### REMARKS/ARGUMENTS

Application Serial No. 09/771,471  
Customer No.: 26021  
Reply to Office Action Dated August 24, 2004

PATENT  
1892-174 (81841.0044)

Figure 2

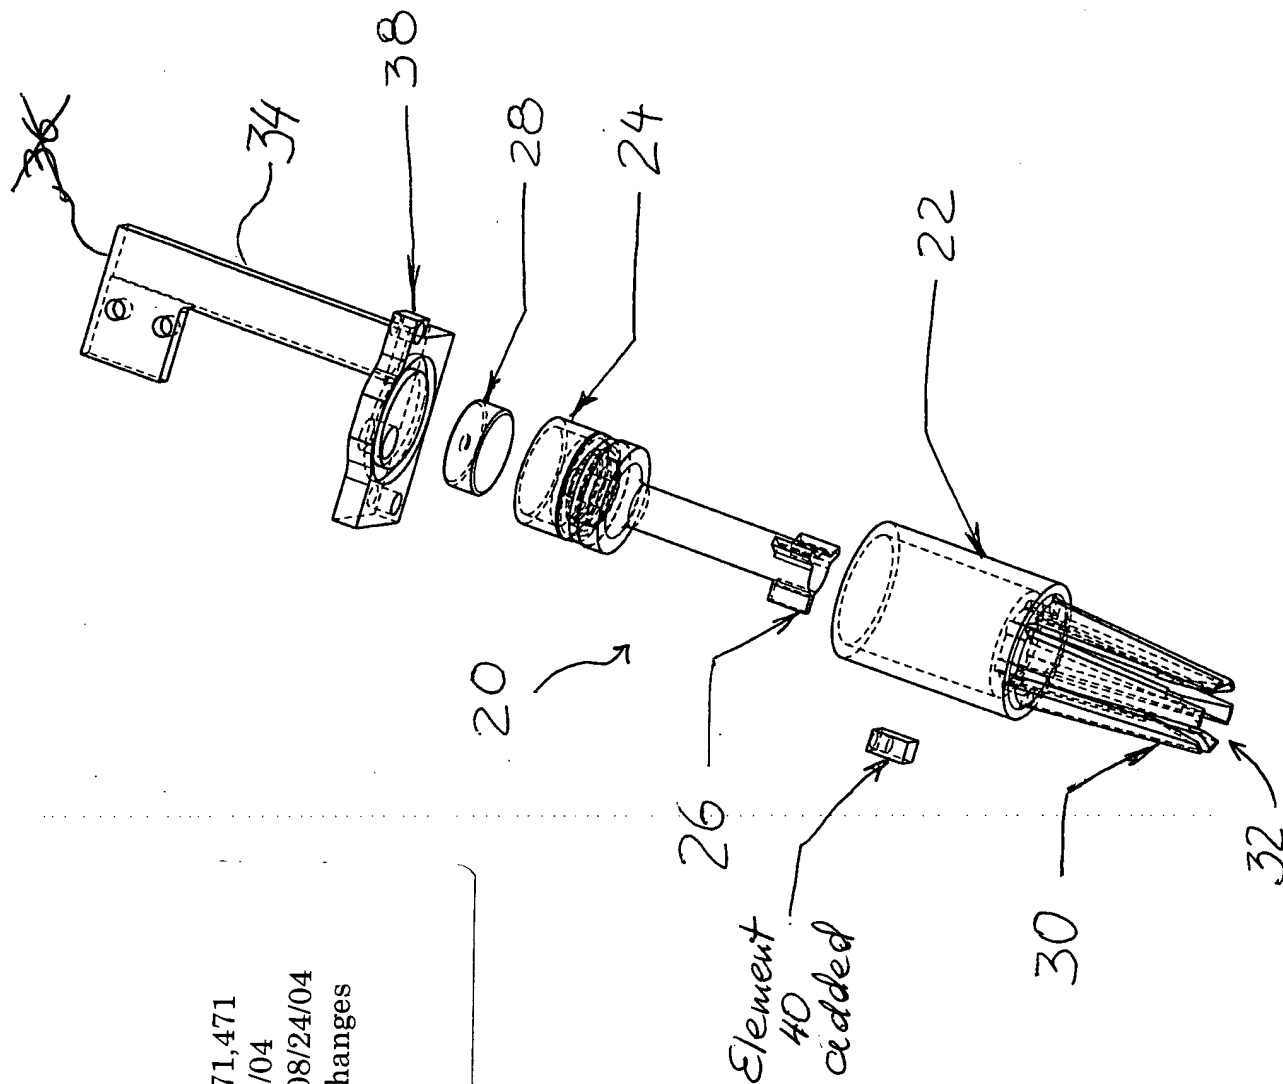
The drawings were objected for not showing adapter recited in claim 2 and sensor recited in claim 9. The adapter was shown in the original Figure 2 (reference numeral 34) but was not referred to by its reference numeral in the specification. Applicants amended the specification as shown above to add reference numeral 34 to the description of the adapter.

Thus, according to 37 CFR 1.83, the sensor of the present invention should be illustrated in the drawing in the form of a graphical drawing symbol or a labeled representation (e.g., a labeled rectangular box). Accordingly, applicants added such a schematic representation of the sensor 40 to Figure 2 and amended the specification as shown above to provide a proper reference to the sensor. These amendments overcome Examiner's rejections of the drawings. Corrected drawing sheet in compliance with 37 CFR 1.121(d) is attached.

The attached sheet of drawings includes changes to Fig. 2 and replaces the original sheet including Fig. 2. In Figure2, previously omitted element 40 has been added. Also, the reference numeral 36 that is not used in the specification has been deleted.
